NOTES

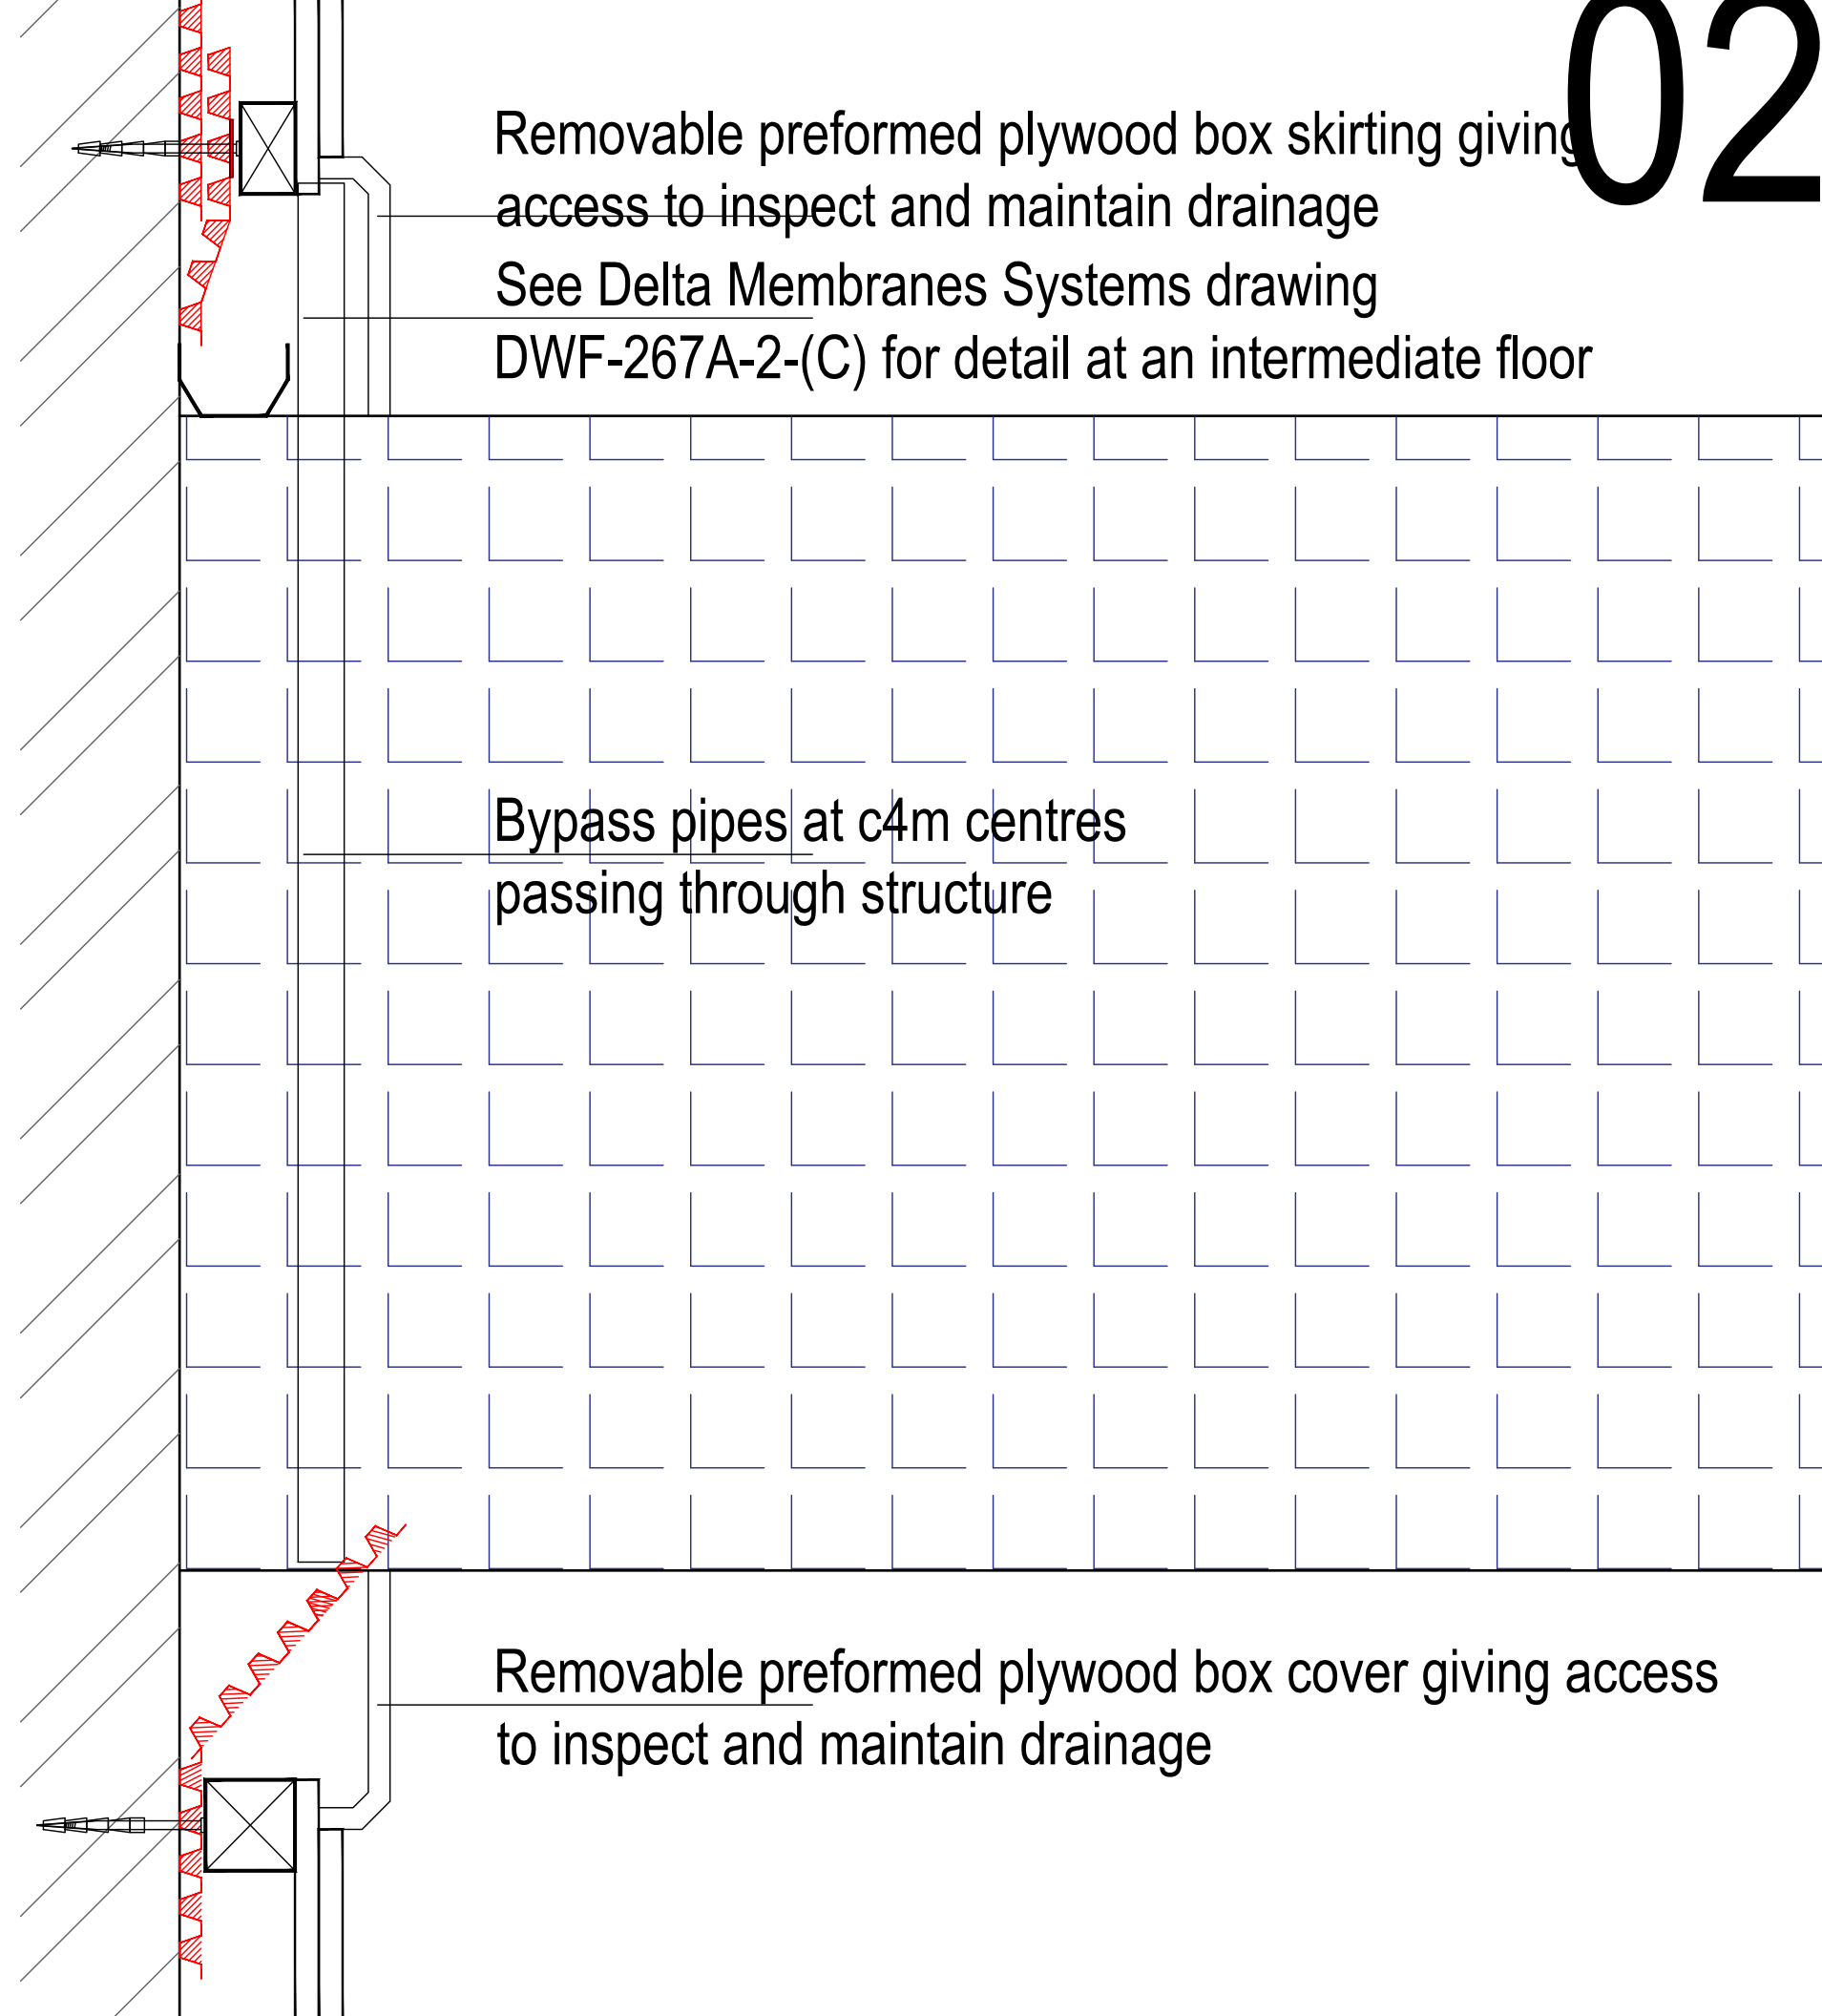
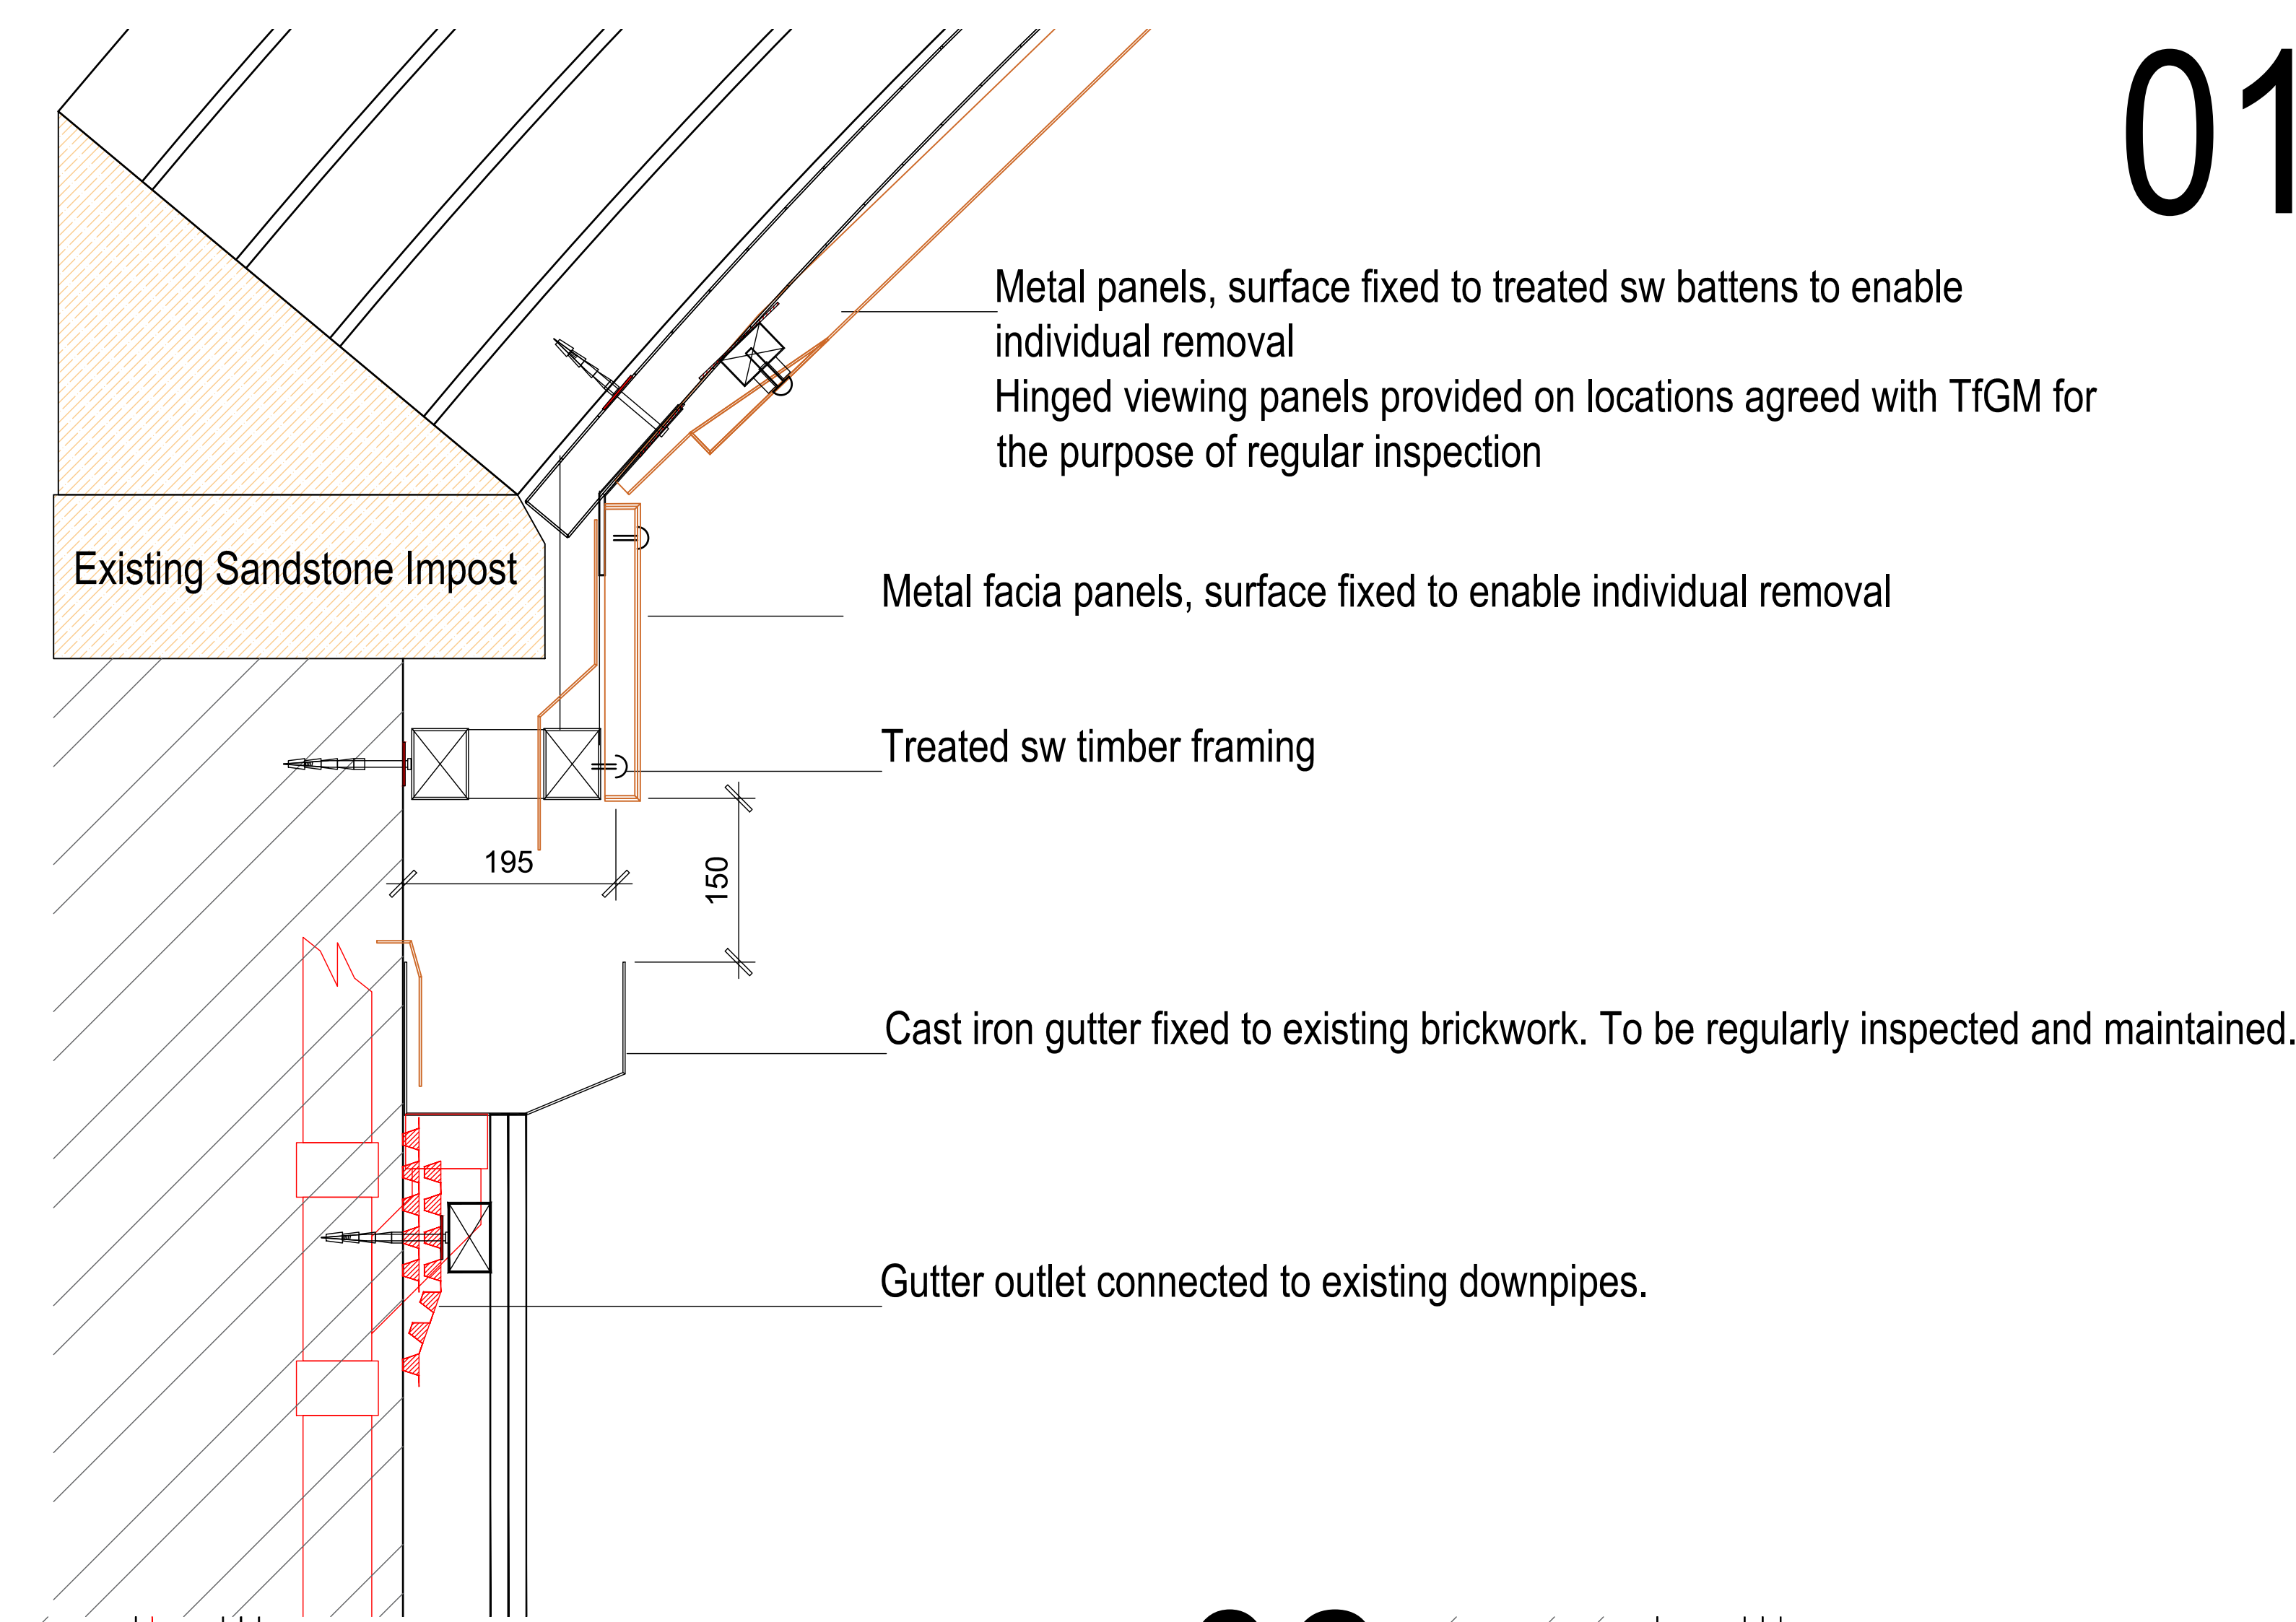
Rev	Date	Notes	By	Chk
P1	03.09.2023	Detail 5 added: Weep pipes added.	MAS	EW
P2	26.09.2023	Additional space allowed for gutter clearing	MAS	EW
P3	14.05.2023	Weep drain detail amended (100mm core drill holes)	MAS	EW
P4	26.06.2024	Timber framing to Sandstone Impost amended	MAS	EW
P5	26.09.2024	Additional drive added	MAS	EW
P6	22.07.2024	Detail 01 amended	MAS	EW
P7	10.02.2026	Type C lining omitted from soffit panels: weep holes omitted	MAS	JGBB
P8	16.02.2026	Type A lining reinstated at head of Arch soffit	MAS	JGBB
